PALISADES PLANT

AMENDMENT TO PROVISIONAL OPERATING LICENSE

Amendment No. 31
License No. DPR-20

ATTACHMENT TO LICENSE AMENDMENT NO. 31

Reactor Core Safety Limits 2 Pump Operation	Palisades Technical Specifications	Figure 2-1

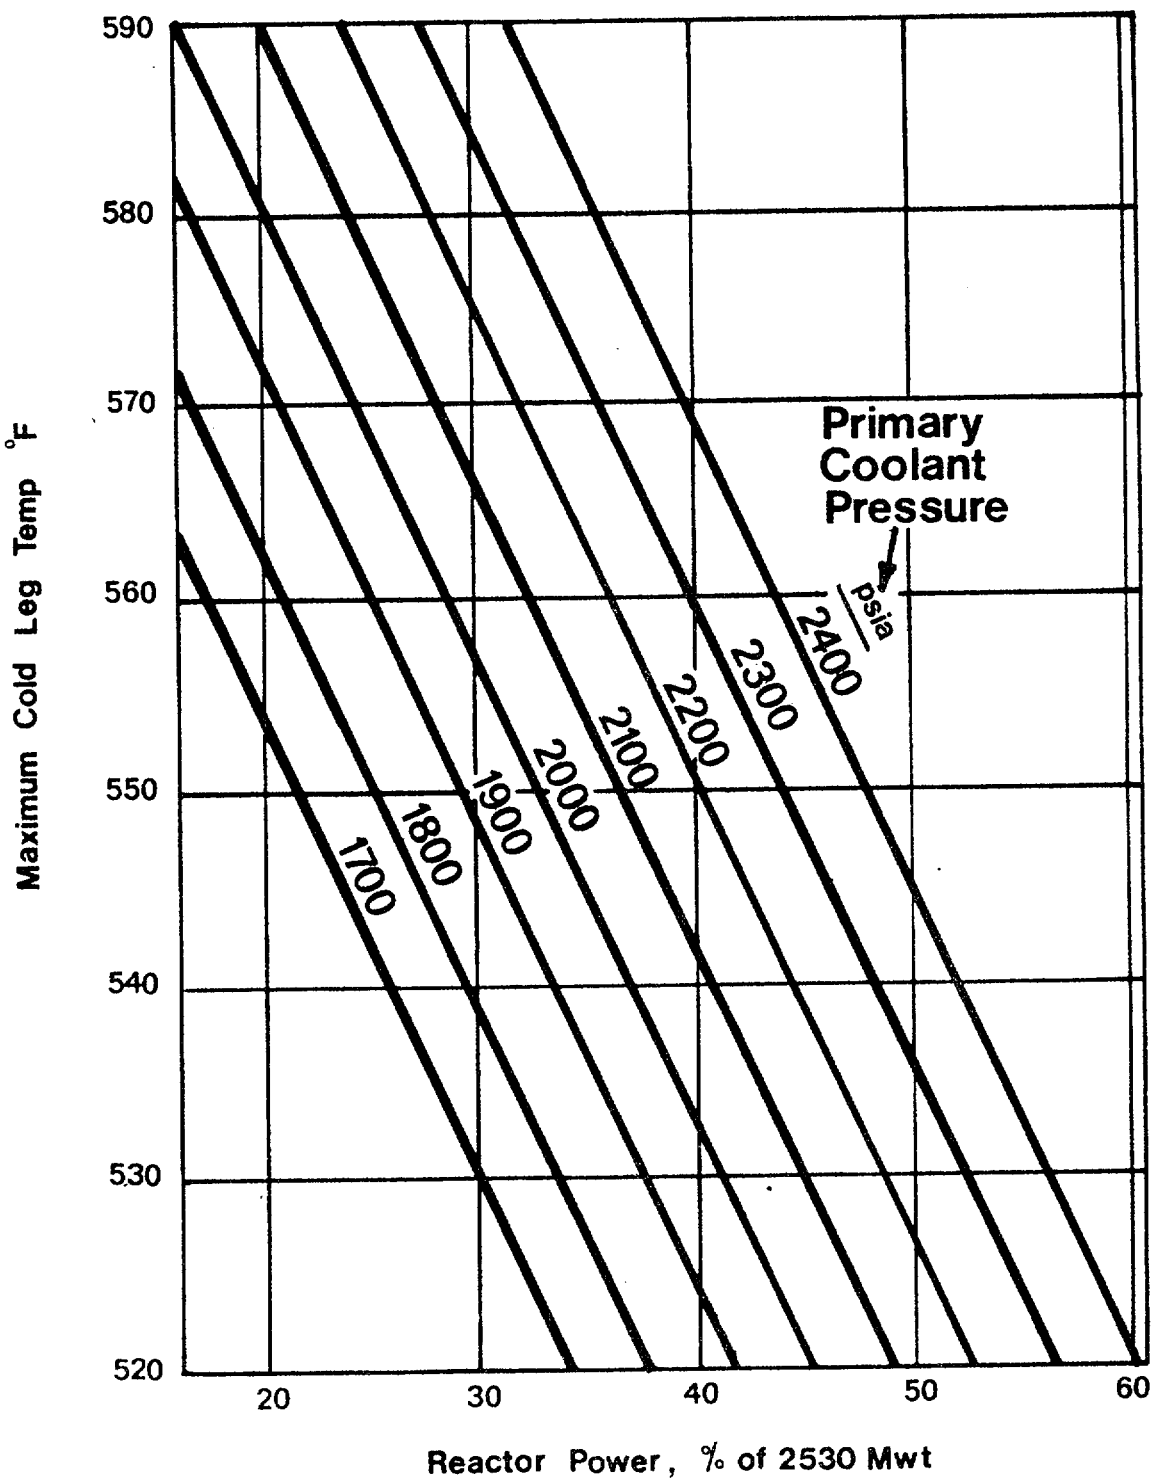
Sec. 2.1 (Figs. 2-1,-2,-3) Reactor Core Safety Limits for 2, 3 and 4 Pump Operation have been modified for 2530 MWt operation.

FIGURE 3-0
REACTOR INLET TEMPERATURE
VS
OPERATING PRESSURE

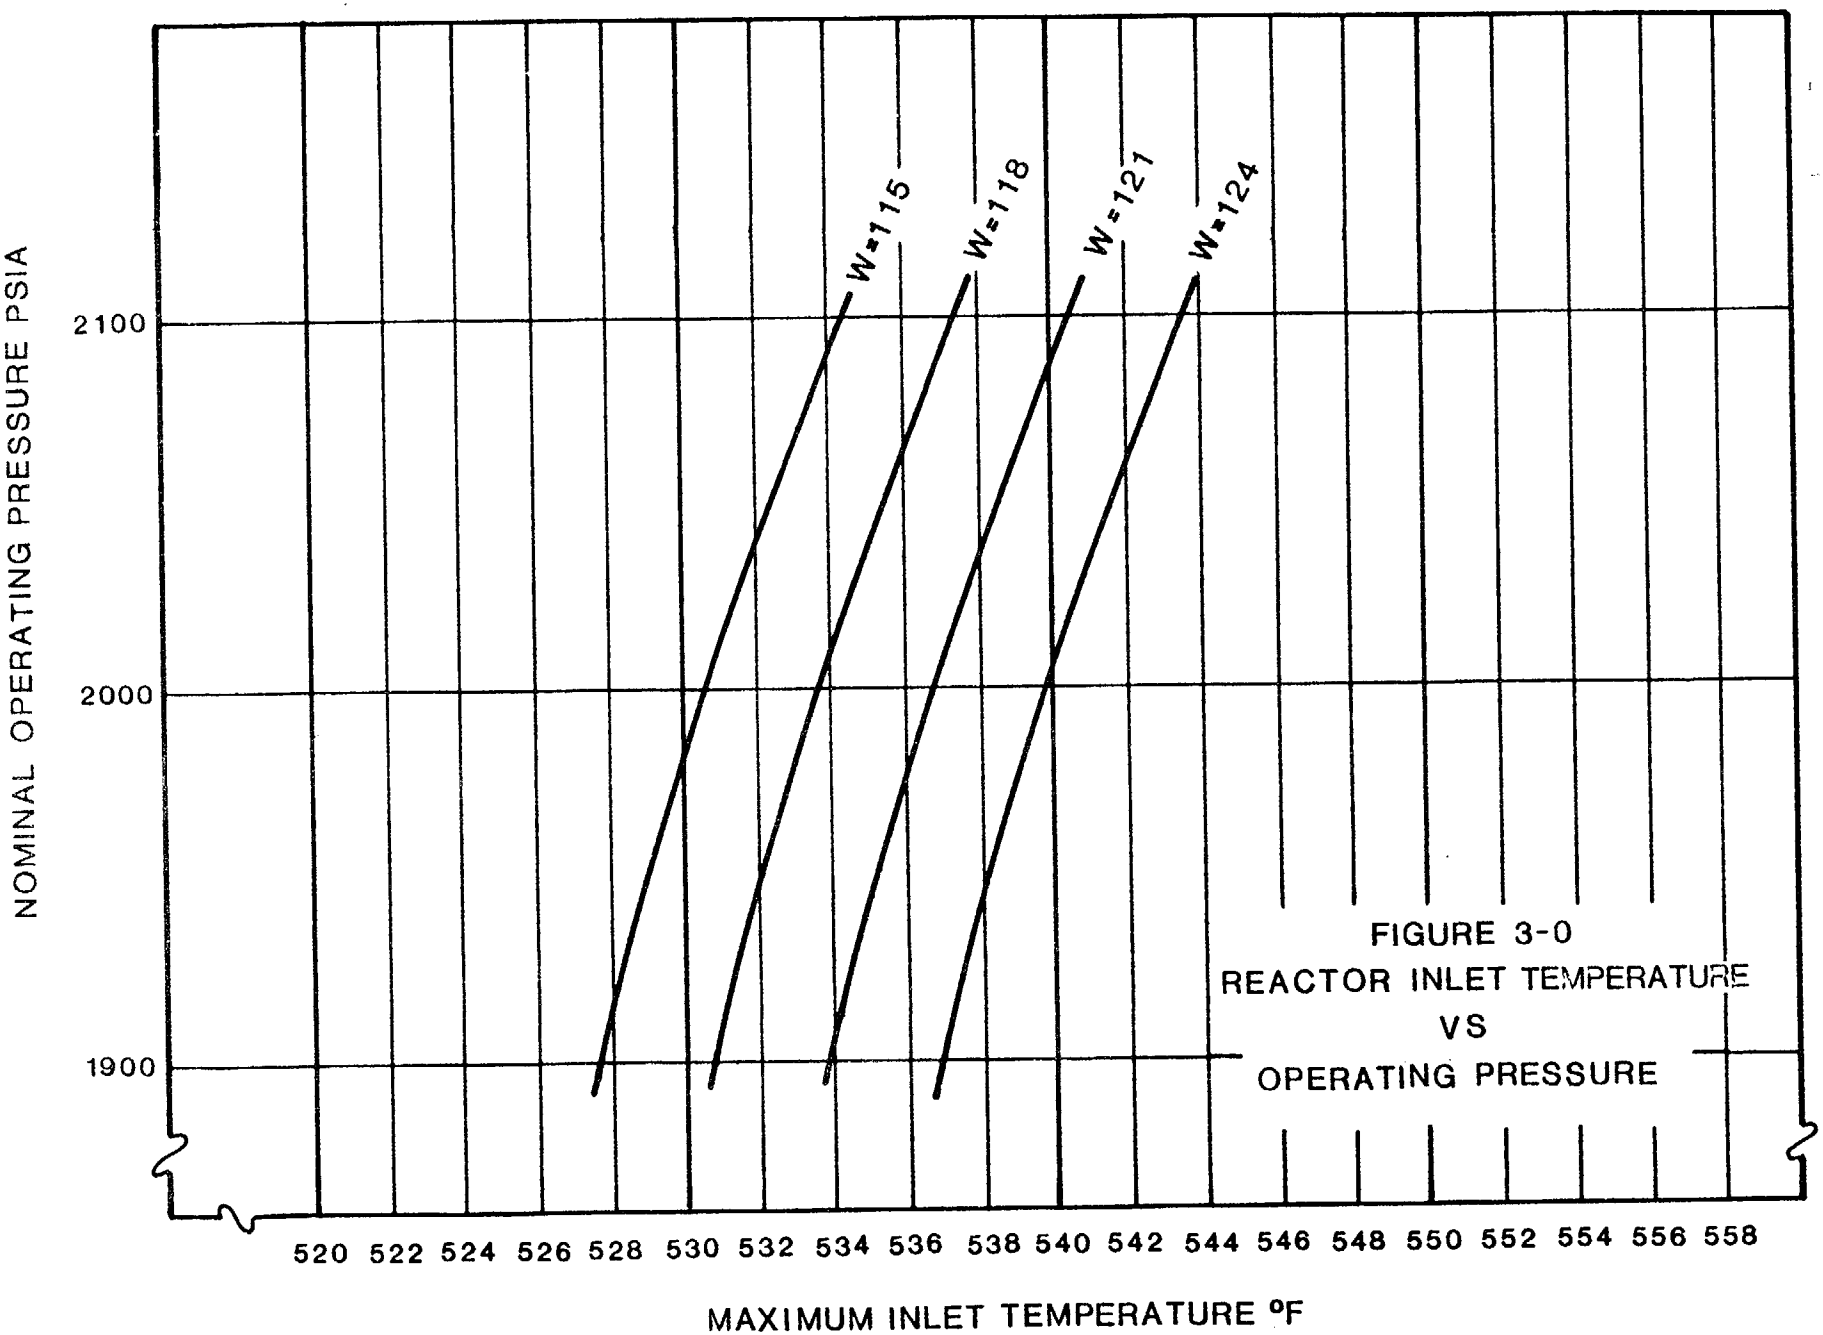
Sec. 3.1.1 (p3-1a, Fig. 3-0) Reactor Inlet Pressure VS Operating Pressure for a given mass flow rate has been modified for 2530 MWt operation.

CONTROL ROD INSERTION LIMITS	PALISADES TECHNICAL SPECIFICATION	FIGURE 3-6

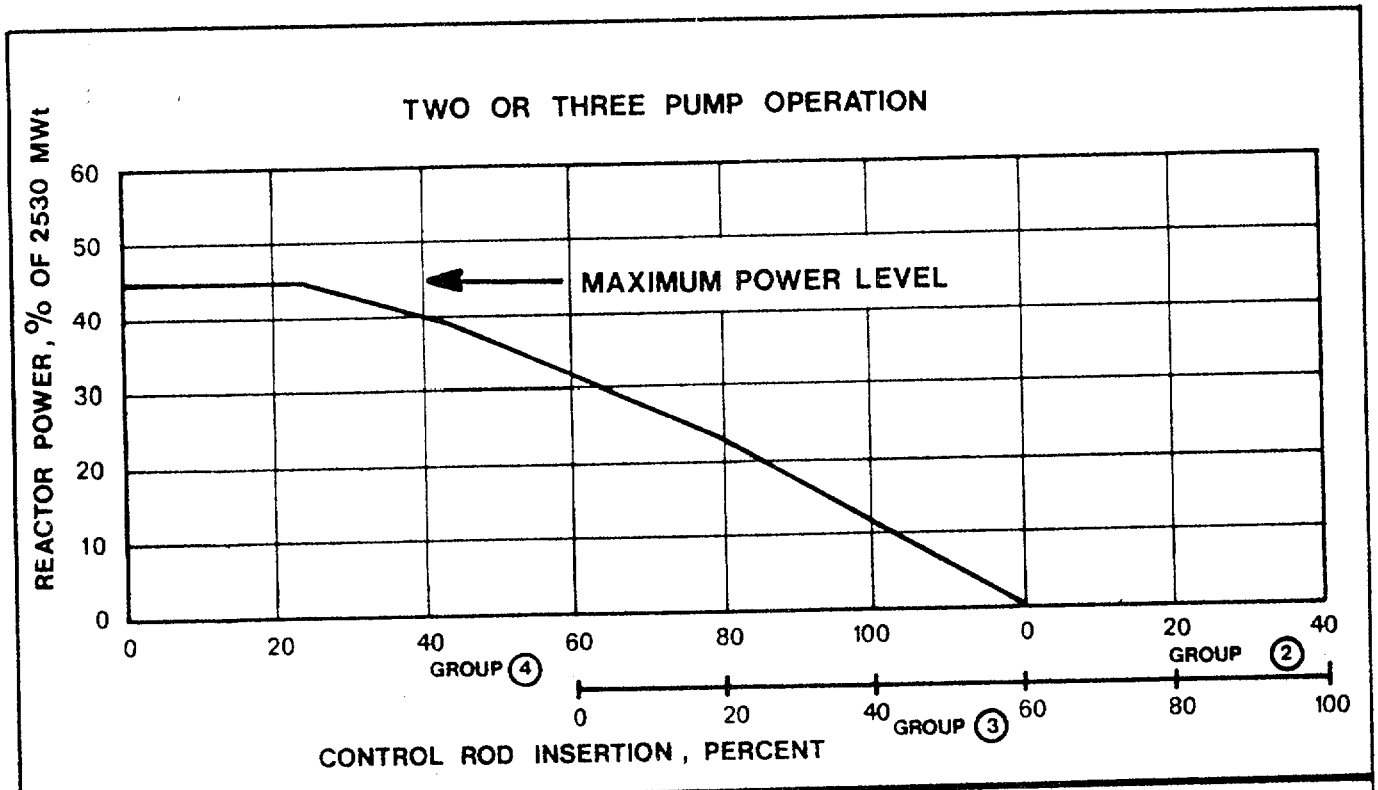
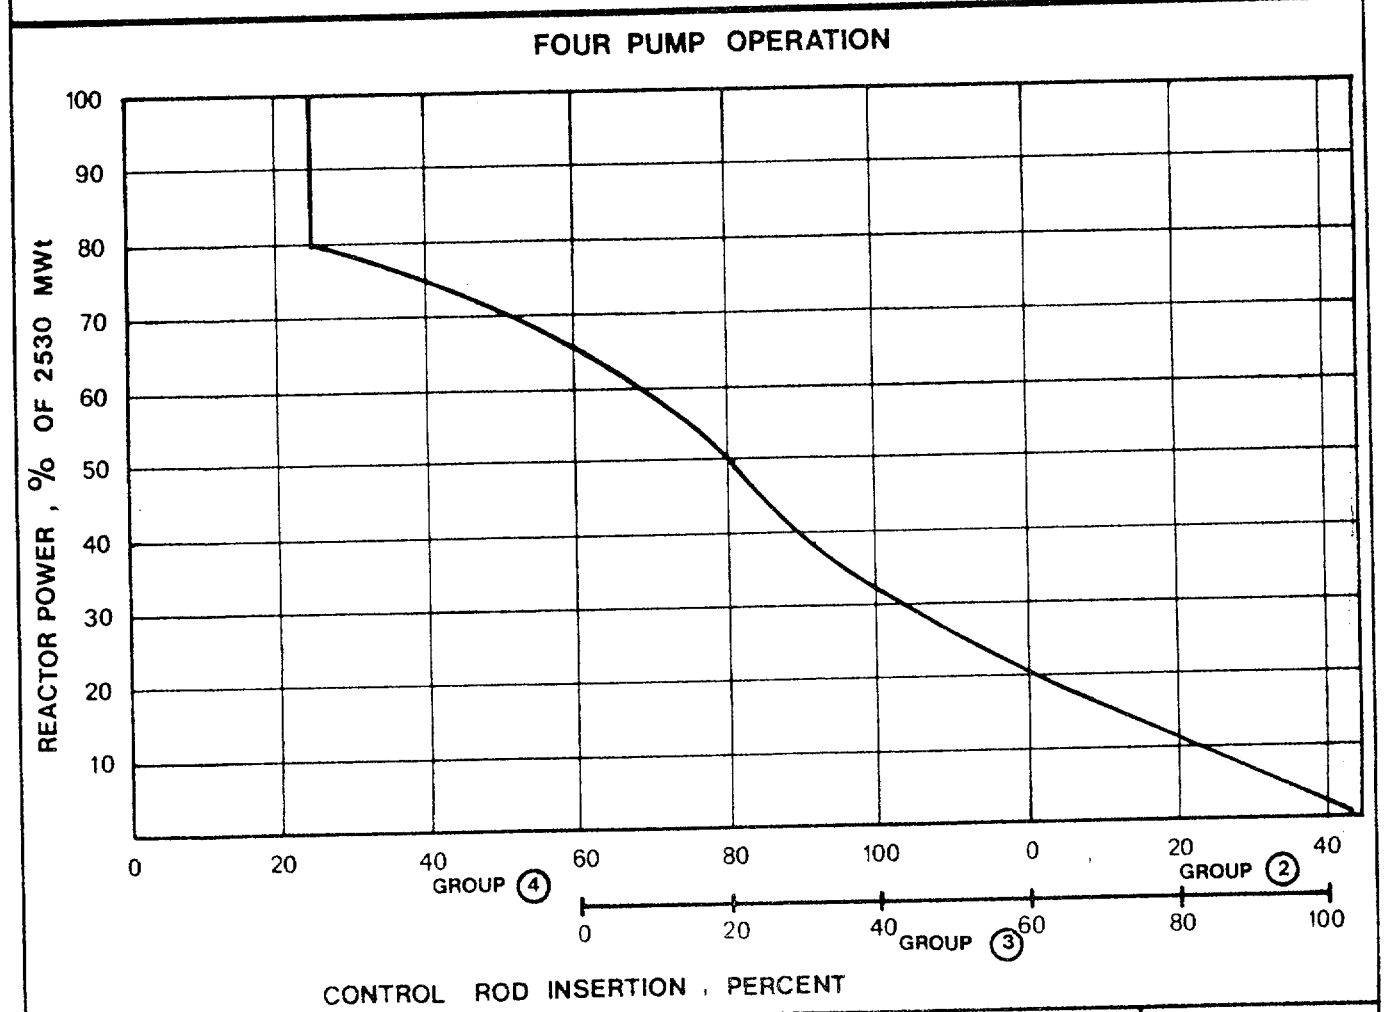
Sec. 3.10.5 (Fig 3-6) Control Rod Insertion Limits have been modified for 2530 MWt operation.

Axial Correction Factor For Peak Linear Heat Generation Rate	Palisades Technical Specifications	Figure 3-9

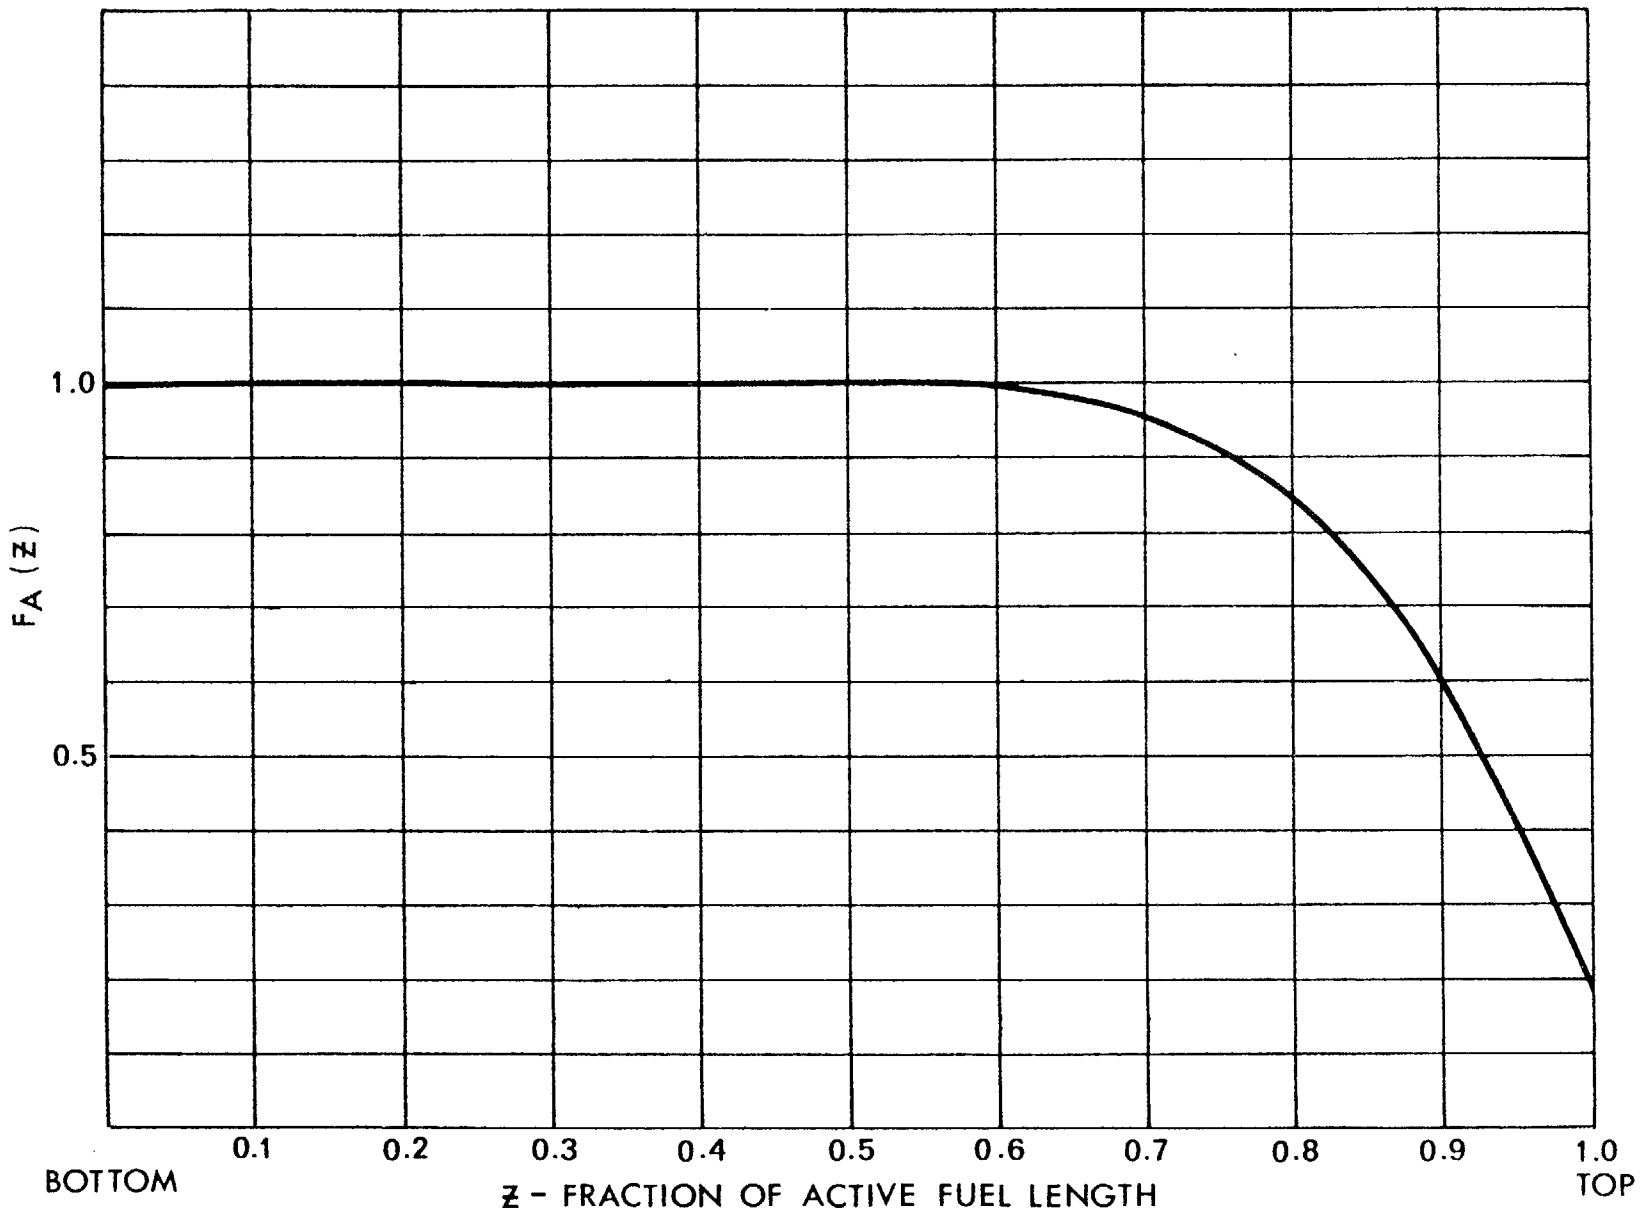
Sec. 3.10.3 (p3-58, 59, Fig 3-9) The Power Distribution Limits have been modified for 2530 MWt operation. PLHGR is consistent with the LOCA analysis and an axial power distribution term has been provided which replaces the upper to lower half of the core power ratio.
